Please find below the comments of the editor and the two reviewers. Our replies are in *italics* and preceded by ">>" and the page and line numbers refer to the revised manuscript.

>> *Thanks for your thoughts and suggestions for the title of our manuscript. We have changed the title in "Testing the use of standardised indices and GRACE satellite data to estimate the European 2015 groundwater drought in near real-time".*

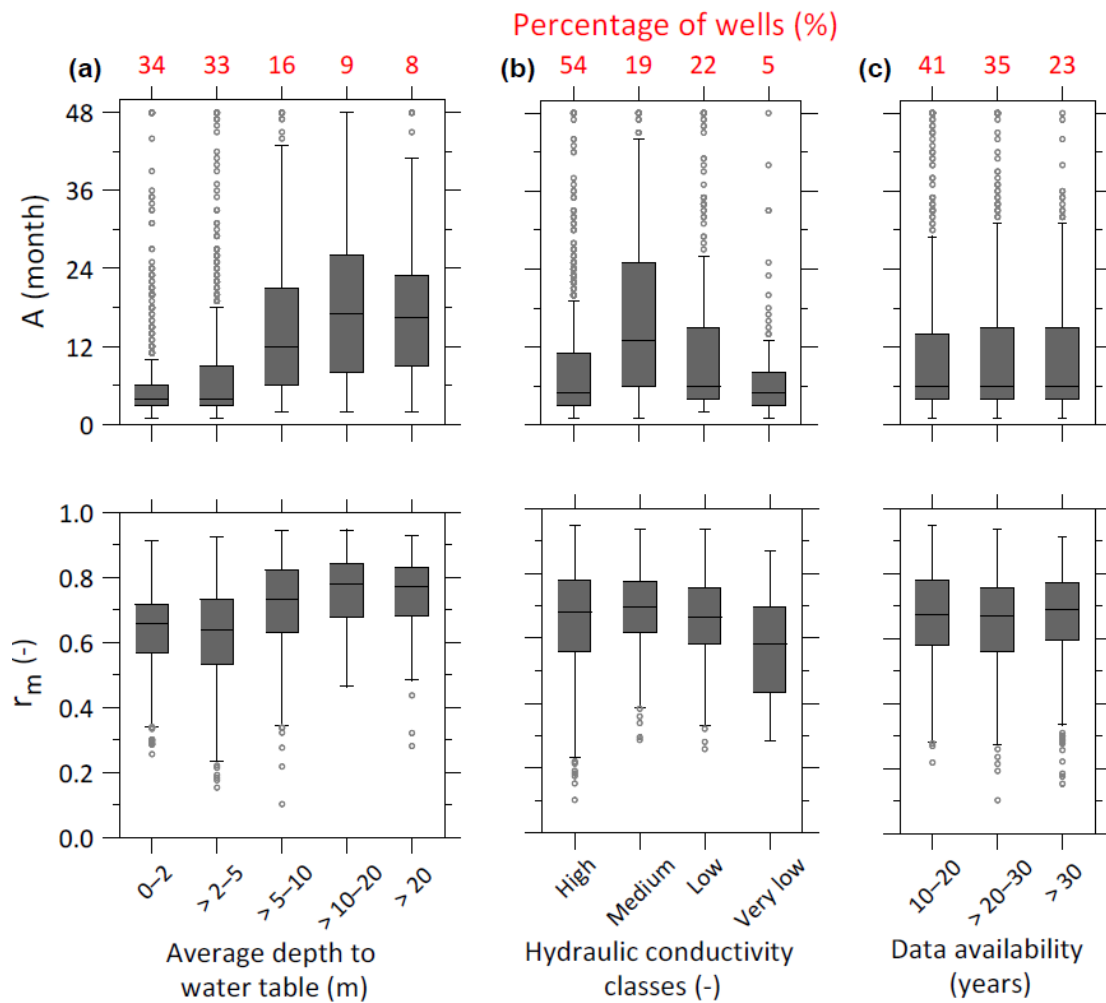
P4., last para - when working with standardised indices such as SPI or SGI it is common practice to produce standardised values on a common time period and with a minimum record length of 30 years (McKee et al 1993 and others). What errors have been introduced into the analysis due to differences in record lengths within and between the two study regions and do these errors effect the conclusions of the study given that “The length of [the groundwater level] records varied from well to well with a minimum of 10 years, starting from the year 1951 for the German wells and 1988 for the Dutch wells and ending in the year 2013”?

>> We are aware of the advice to use a minimum record length of 30 years and our failure to comply with this. In our previous paper using these groundwater drought observations (Kumar et al. 2016), we quantified the error in the SPI accumulation period and max. correlation caused by the varying record lengths (see figure below). This was what we wrote about it:

“We also tested the reliability of the above results against the data availability issue. The A [optimum accumulation period] and rm [max. correlation] obtained across all wells were grouped into three categories according to their available record lengths (i.e., into 10–20, > 20–30, and > 30 years). Both the spread and the average behavior of the optimal accumulation period (A) and the maximum correlation (rm) were comparable across the group of wells with different record lengths (Fig. 3c and d). This shows that the above-presented results are reliable and are not contingent on the selection of wells with either short or long record lengths.”

Based on the similarities in the data used for this paper, we assume that equally in this work there is no effect of record length on optimum accumulation period between SPEI and SGI. This assumption is now included in Section 2 (p.5 l.26-28).

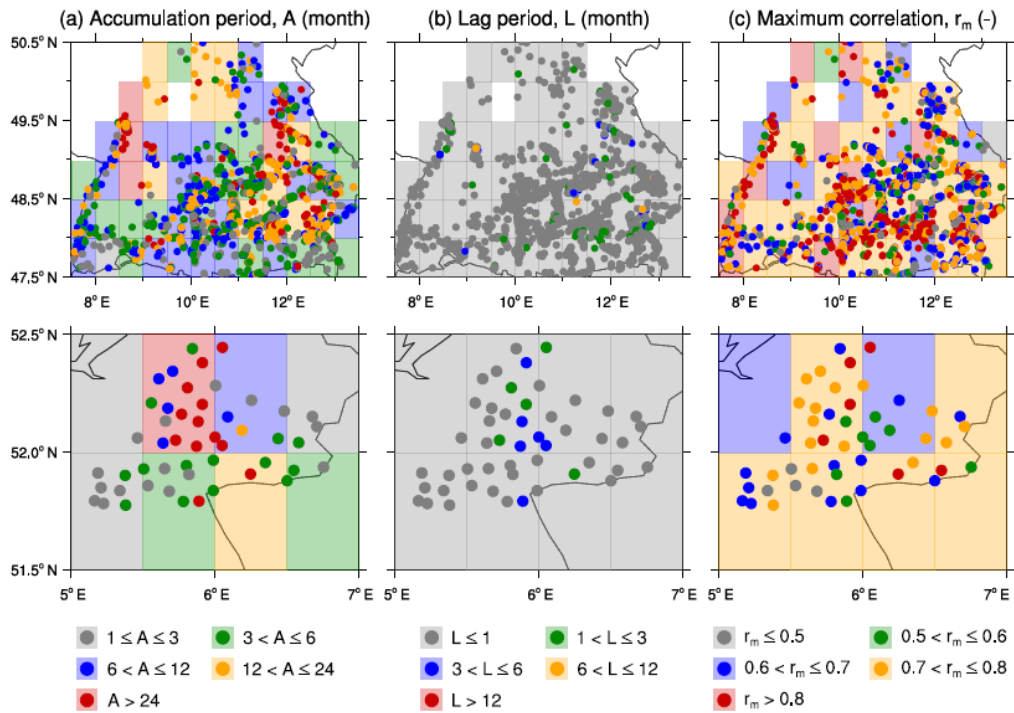
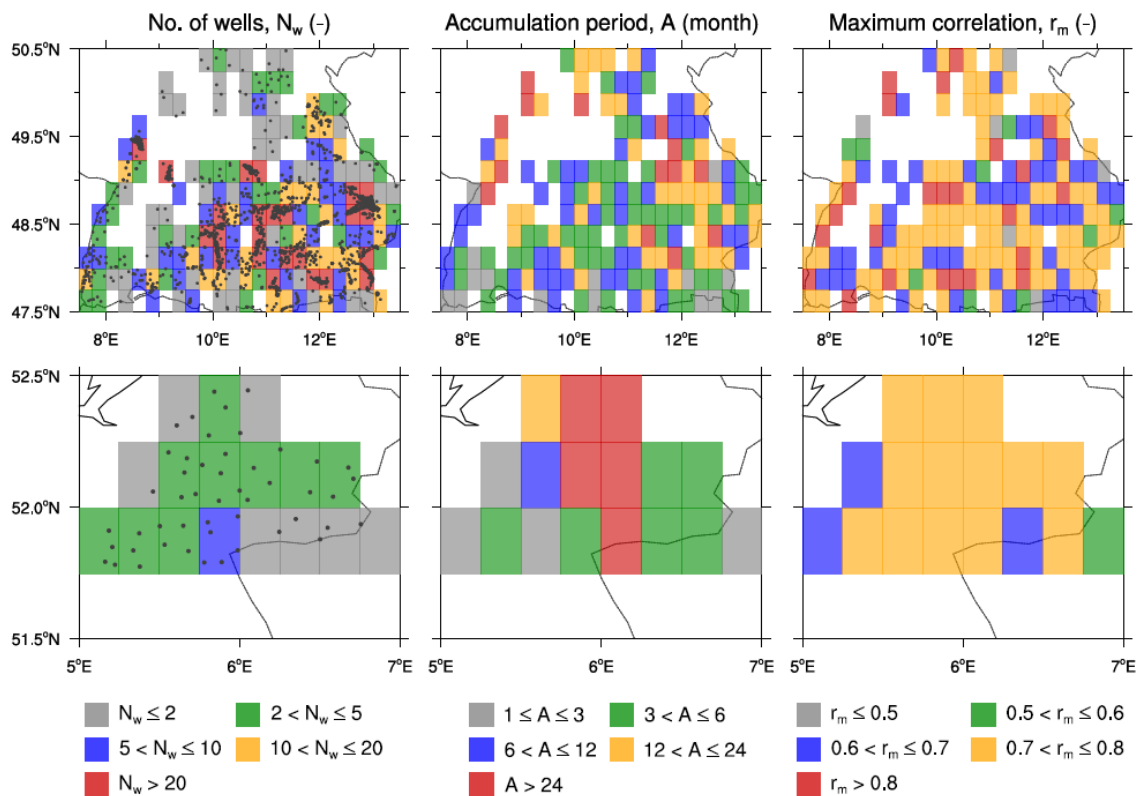
P5-6. Section 3.1 and Fig 2 (top and middle panels) – the SGI data is the same as Kumar et al. (2016) and the difference between Fig 2 of Kumar et al. (2016) and Fig 2 (top and middle panels) of this study is that the latter uses a more refined grid for the analysis. What are the implications, if any, of the reduced number of groundwater level time series observations within the smaller grid cells of the present study on the averaging procedure to obtain a representative SGI for each cell?

>> The refined grid indeed means that fewer groundwater boreholes are used in the determination of optimal accumulation period of SPEI to match SGI. The advantage of that is that less spatial variability in groundwater is averaged out, which is clearly visible when comparing Fig. 2 from Kumar et al. (2016) with Fig. 2 of the current manuscript (see both below). The pattern of accumulation periods of the refined grid (this paper) matches much better that of the individual wells (Kumar et al.,

2016) than the coarser grid of Kumar et al. (2016). We mention this in the revised manuscript (p.11 1.9-14).
